DSO6014L-01-S

Safety Service Note

DSO6014L Oscilloscope, LXI, 4-channel, 100 MHz

POSSIBLE "SHOCK" HAZARD

Figure 13 Removing the cover

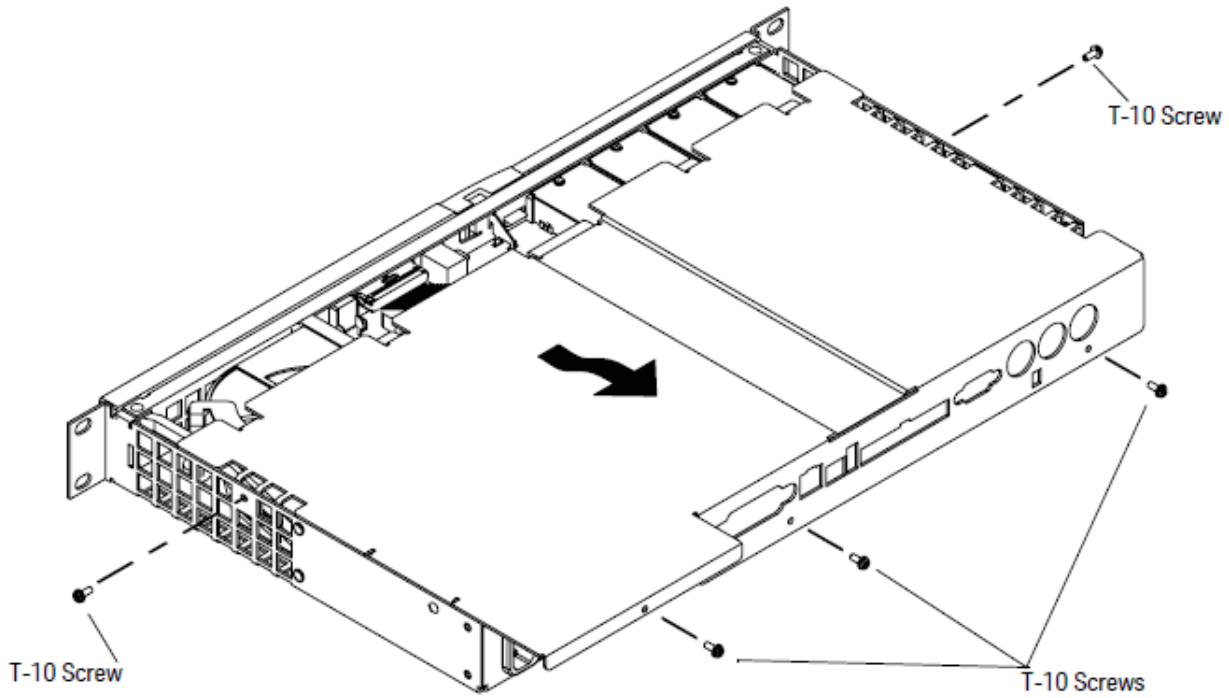
- replace the existing Cover Assembly with a new Cover Assembly without the foam EMI gasket
 - and to apply a new clip-on EMI Gasket Fingerstock (D6104-00104) to the affected units.
1. Remove and scrap the original cover assembly (D6104-00104) with the foam EMI gasket from the scope.
 - Turn off the oscilloscope and disconnect the power cable.
 - Turn the oscilloscope so the bottom is facing up.
 - Using a T10 screwdriver, remove 5 screws from the rear and sides of the cabinet.
 - Slide the bottom cover back and up to remove.

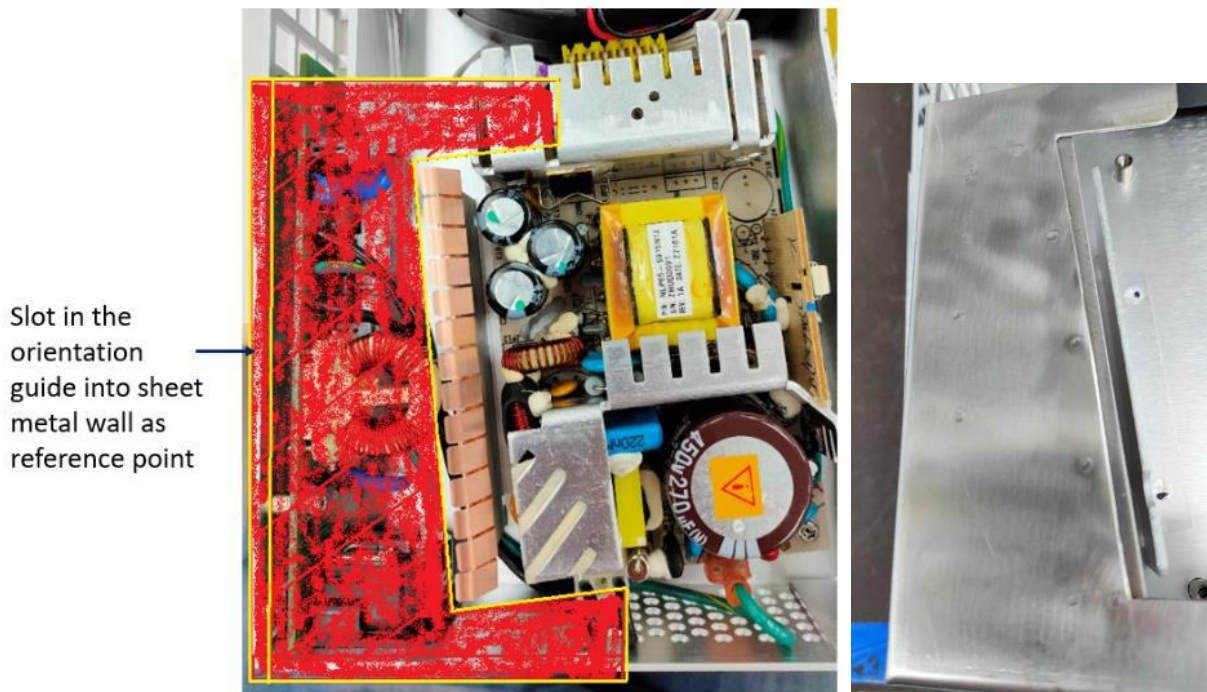
2. Prepare the Gasket Orientation Guide and 1pcs of the new Clip-on EMI Gasket Fingerstock (D6104-85405) as shown below:

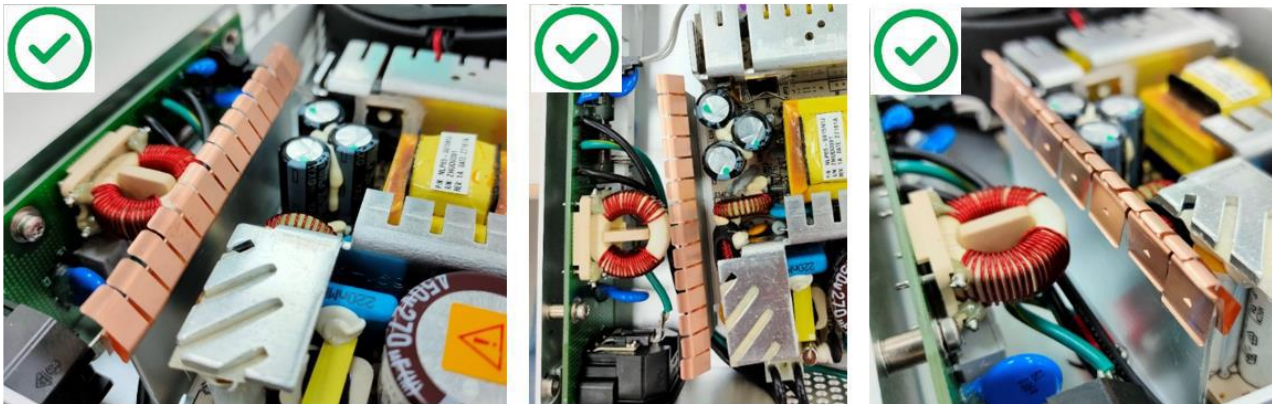
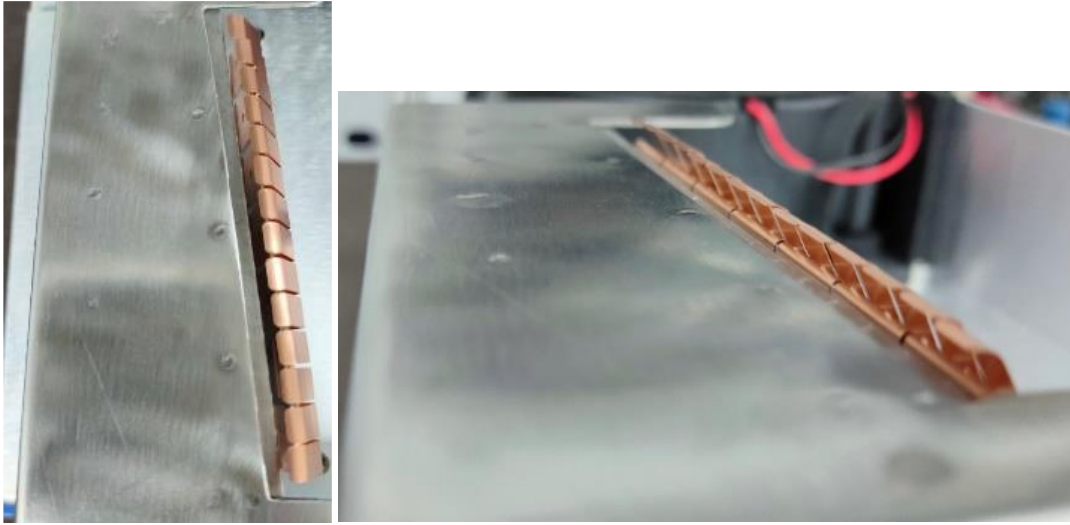
3. Slot in the Gasket Orientation Guide into the chassis as shown in the picture below:

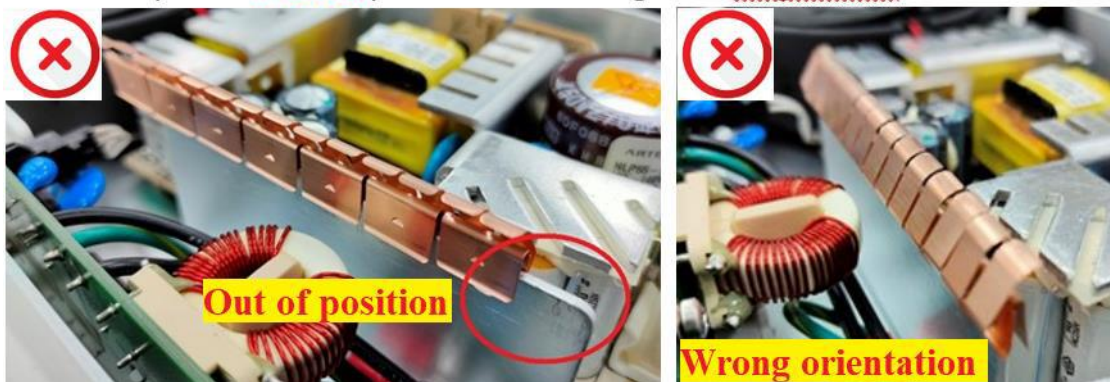
4. Insert the Clip-on EMI Gasket Fingerstock (D6104-85405) into the sheet metal divider and press it with finger force until it is fully inserted as shown in pictures below.

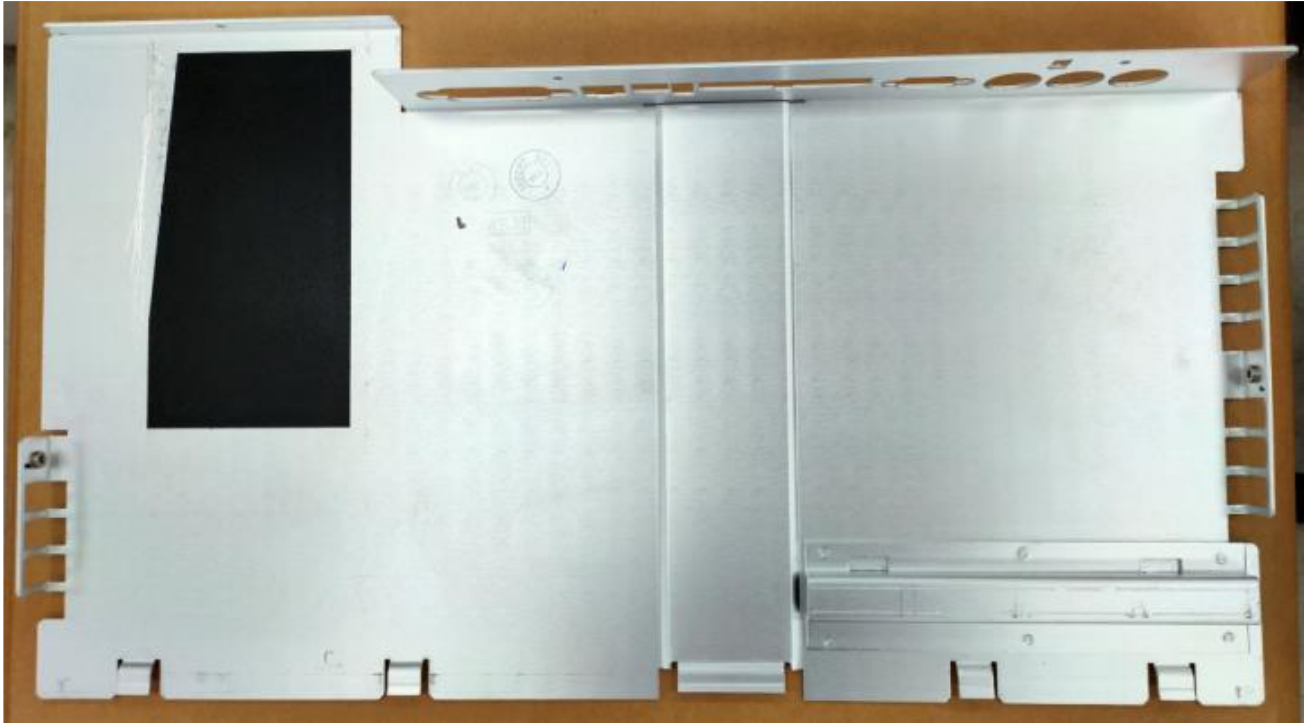
Example of **WRONG** placement of EMI gasket Fingerstock as below:
